## **ENERGY STAR Residential New Construction Roadmap Comments**

This is a compilation of all comments received by EPA during and after the ENERGY STAR Residential New Construction Roadmap comment period.

**Note:** This operating-cost analysis is for a specific single-family house type and size, 2376 square foot living space over an 1188 square foot conditioned basement. These results cannot describe single-story, slab homes and townhome performance. REM/Rate 15.8 modeling software.

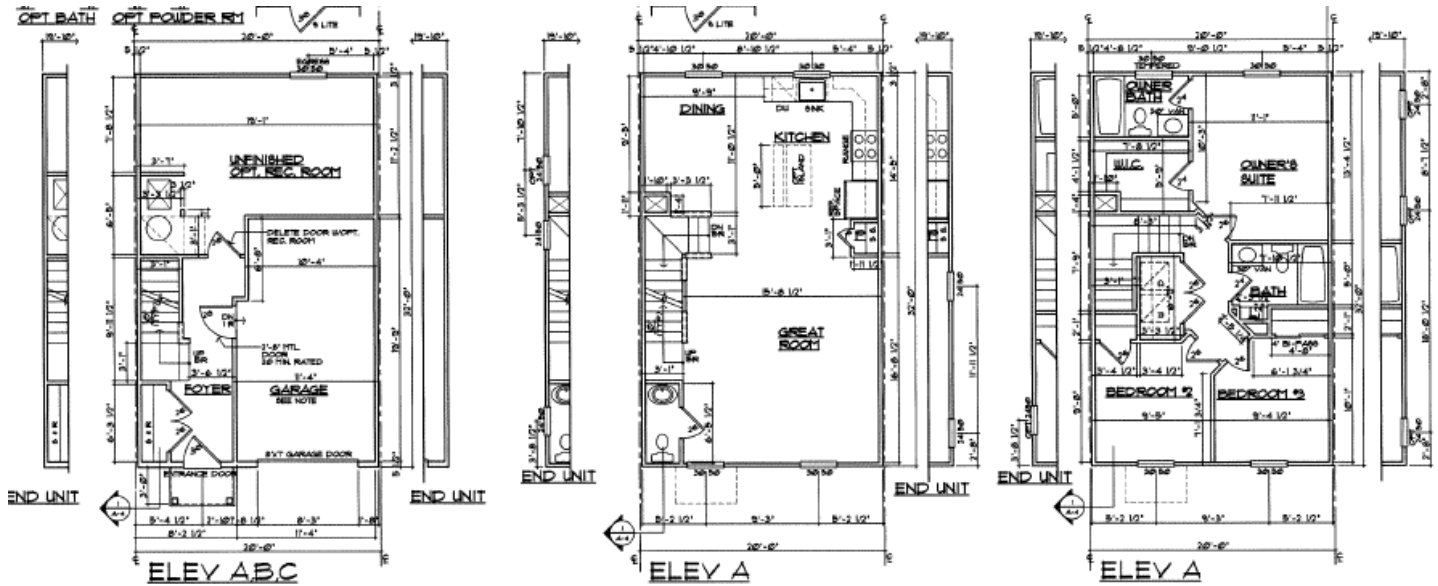
<b>2021 Baseline + .95 UA, .38 SHGC:</b> 40% attic Ducts @ 4% LTO	<b>DOE 2018 Mod.R20 wall, R49 attic:</b> 40% attic Ducts @ 4% LTO	<b>DOE 2018 Mod.R20 wall, R49 attic:</b> Ducts inside, 1% LTO	<b>DOE 2018 Mod.R20 wall, R49 attic:</b> Ducts inside, 1% LTO, 9.2 HSPF / 16 SEER HP
<ul style="list-style-type: none"> <li>• \$1,870 annual cost.</li> <li>• UA 304.4</li> <li>• ERI 62</li> </ul> Comments: Based on DOE’s reference house, 1188 square foot, 2-	<ul style="list-style-type: none"> <li>• \$1,998 annual cost.</li> <li>• UA 337.1</li> <li>• ERI 63</li> </ul> Comments Modified DOE reference house increases operating costs \$128 or 6.8%.	<ul style="list-style-type: none"> <li>• \$1,784 annual cost.</li> <li>• UA 337.1</li> <li>• ERI 57</li> </ul> Comments Moved ducts inside, held thermal features at modified levels, thus no change in UA	<ul style="list-style-type: none"> <li>• \$1,748 annual cost.</li> <li>• UA 337.1</li> <li>• ERI 56</li> </ul> Comments: Combined ducts and HVAC equipment. Savings is 6.5% as compared to DOE baseline

<p>sty over basement. Glass at 15% floor area.</p> <p>R408 measure UA at .95 and .38 SHGC was included, which allows comparison to all R408 Additional measures</p>	<p>Associated building costs</p> <p>Sheathing: 73 x \$50 = \$3,650</p> <p>Attic: 1188 x \$.42 = \$500</p> <p>Energy benefit: \$4,150 / \$128 = 32.42 years</p> <p>Appraisers may have to discount these features due to &gt; 30 mortgage</p>	<p>Operating costs reduced 4.6% as compared DOE baseline. Covered change from modifying thermal features.</p> <p>Energy benefit: Reduced thermal costs may offset increased framing costs to consider floor framing changes</p> <p>Appraisers and lenders can support reduced building costs that generate greater savings.</p>	<p>\$122 annual energy savings for equipment and ducts</p> <p>Energy benefit: Equipment is estimated at \$1,200 marginal cost vs. 14/8.5 heat pump.</p>
---	--	---	---

*Previous versions of Energy Star aligned the thermal backstop with the code that was in place prior to the update. We used 09' as the backstop for v.3.0 & v.3.1. V.3.2 is assigning thermal backstop that is the code it aligns with. I have already shown that these thermal measures are not cost-justified when applying reasonable pricing to purchase and install. I am not optimistic that "reasonable pricing" will exist in 2023 when builders must consider continuing with Energy Star in Maryland.*
